# BPA/LOWER VALLEY TRANSMISSION PROJECT

Final Environmental Impact Statement  
DOE/EIS-0267

The comments received on the Draft EIS and responses to the comments are in Chapter 6.

**Figure 2-1. Existing and Proposed Single-Circuit Structures and Right-of-Way**

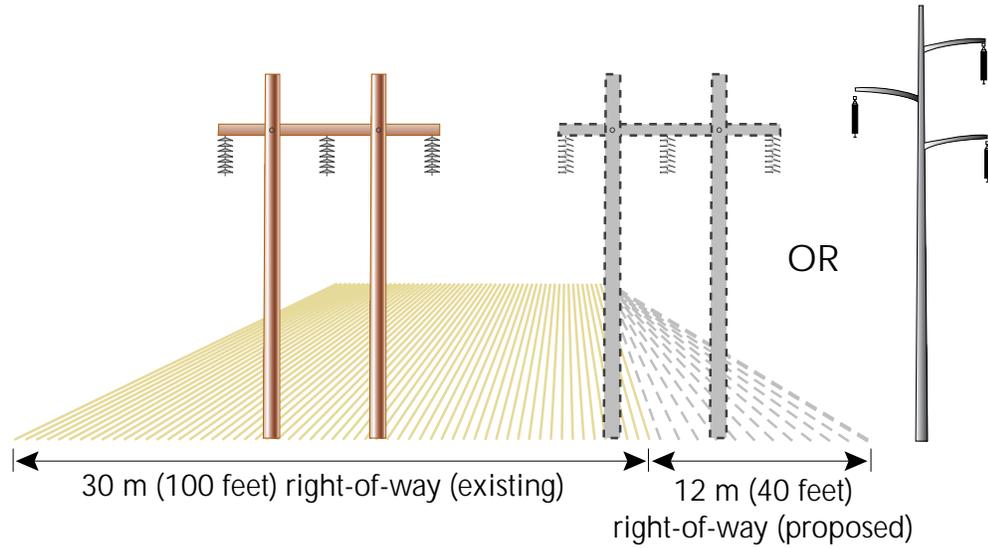
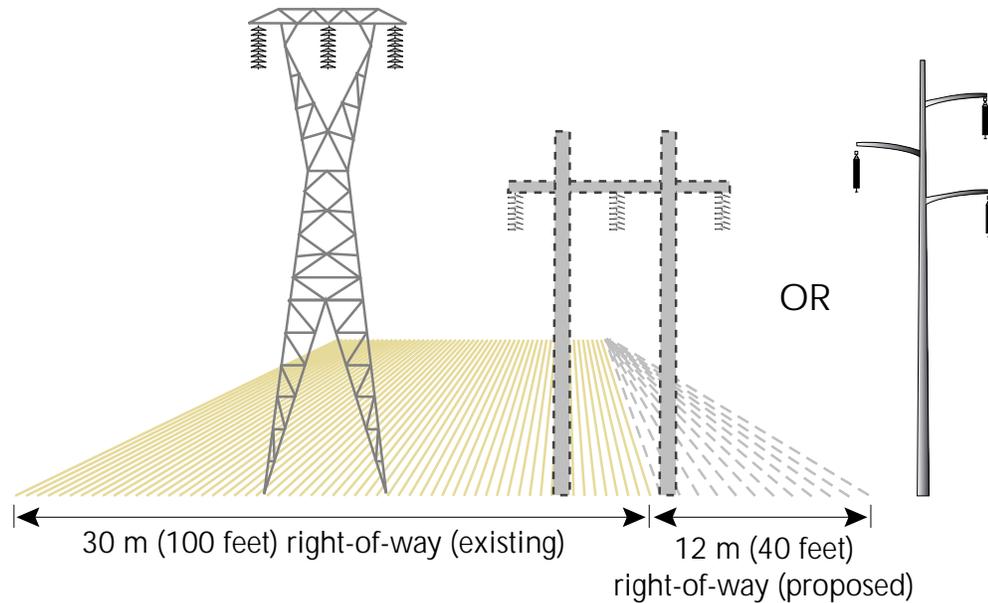
18-29 [ Figure 2-1 should try to estimate the total area disturbed & illustrate it (include area needed for hazard trees)

Figure 2-1 is really meant to be a schematic of the structures and how they would fit next to the existing right-of-way and line. BPA has expanded the discussion in Section 2.1.3 and Appendix J to include the new information for clearing. The revised estimate of right-of-way to be cleared to construct, operate and maintain the proposed transmission line is about 25 hectares (62 acres). Most of the trees in the 25 hectares are small and generally nonmerchantable except for possible fenceposts. BPA also estimates about 6 hectares (15 acres) to be cleared for new access roads. These trees vary from small to larger trees.
